## DEPARTMENT OF TRANSPORTATION

#### Federal Motor Vehicle Safety Standards; Bus Emergency Exits and Window Retention and Release

**ACTION:** Notice of proposed rulemaking (NPRM).

Figure 3D- REAR EMERGENCY EXIT WITHOUT REAR OBSTRUCTION

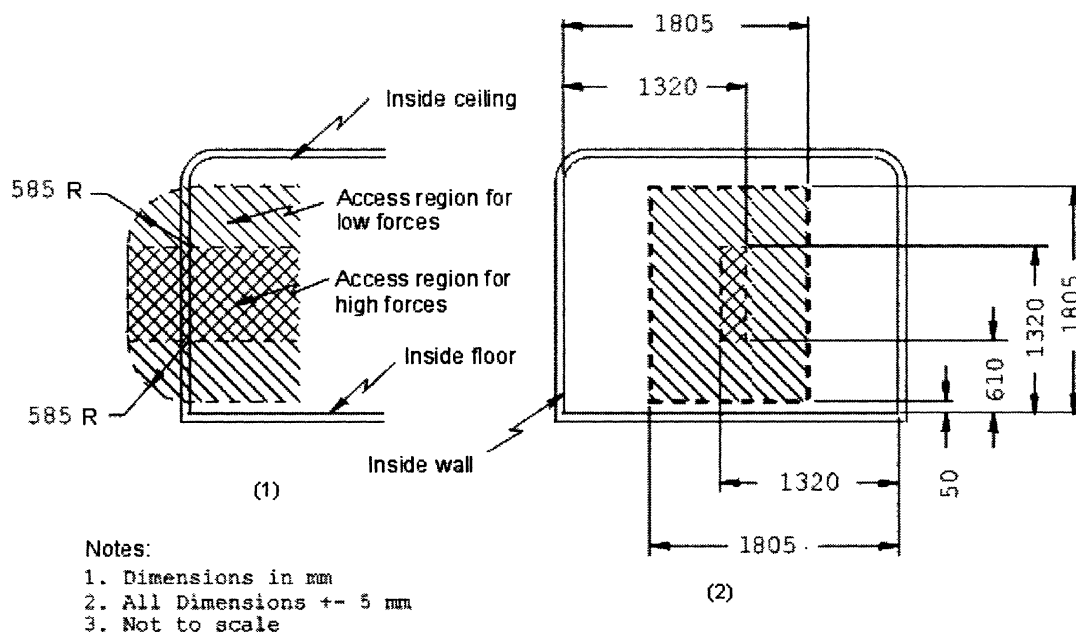
The School Bus Manufacturers’ Technical Council (SBMTC) petitioned the agency to amend FMVSS No. 217 to specify that the exterior release (handle) for school bus rear emergency exit doors may be located near the edge of the door on the side opposite the hinges. Specifically, SBMTC petitioned to amend S5.3.3.1(a) and one of the two drawings in Figure 3D.

S5.3.3.1(a) specifies that the manual interior and outside releases (handles) are located: “Within the high force access region shown in Figure 3A for a side emergency exit door, and in figure 3D for a rear emergency exit door.” Figure 3D consists of two drawings. The left-side drawing shows the vertical dimensions of the high force access region. As shown in the left-side drawing, the release (handle) may be located at any point from the left side of the door to the right. However, the right-side drawing, giving a different perspective of the rear exit, shows that the high force access region is a narrow area in the center of the door. Since S5.3.3.1(a) requires the interior and exterior releases (handles) to be “[w]ithin the high force access region shown in \* \* \* figure 3D for a rear emergency exit door,” the releases must be in that narrow area in the center of the door shown in the right-side drawing of Figure 3D. As noted earlier, in actuality, SBMTC stated that manufacturers are “universally” placing the exterior releases on the side of the doors opposite the hinges.

SBMTC suggests that we reconcile the language of the standard with the practices of the industry and with what petitioner believes is best for safety. The petitioner suggests that we make the right-side drawing of Figure 3D apply only to the interior release (handle) and not to the exterior release. With regard to applying the right-side drawing to the interior release (handle), the petitioner believes there are reasons to require the interior release to be in the center of the door: the location ensures that the release is visible to bus occupants, and is not obscured by seat backs if the door is wider than the bus’s center aisle. Further, we note that the exit would be opened by a pushing rather than pulling

NHTSA agrees. We propose amending the standard to specify that the interior release (handle) for a rear emergency exit must be in the high force access region shown in both drawings of current Figure 3D, and that the exterior release for the exit must only be in the high force access region shown in the left-side drawing of current Figure 3D. Although no manufacturer currently places the exterior release in the center of the door, we request comment on whether we should require the exterior release to be no further than two inches away from the edge of the door. (To clarify the standard, NHTSA proposes that instead of having Figure 3D consist of two drawings, Figure 3D would be easier to understand if the left-side drawing were renamed Figure 3D(1) and the right-side drawing were renamed Figure 3D(2).) We tentatively agree that the school bus manufacturers' current practice of placing the exterior rear emergency exit door release (handle) near the edge of the door on the side opposite the hinges better meets the need for safety than placing the exterior release in the center of the door. Releases (handles) placed opposite the hinges would require less force to pull open the door for persons outside the school bus.

(a) *Location:* Within the high force access region shown in Figure 3A for a side emergency exit door, within the high force access region shown in both Figure 3D(1) and Figure 3D(2) for an interior release mechanism for a rear emergency exit door, and within the high force access region shown in Figure 3D(1) for an exterior release mechanism for a rear emergency exit door.
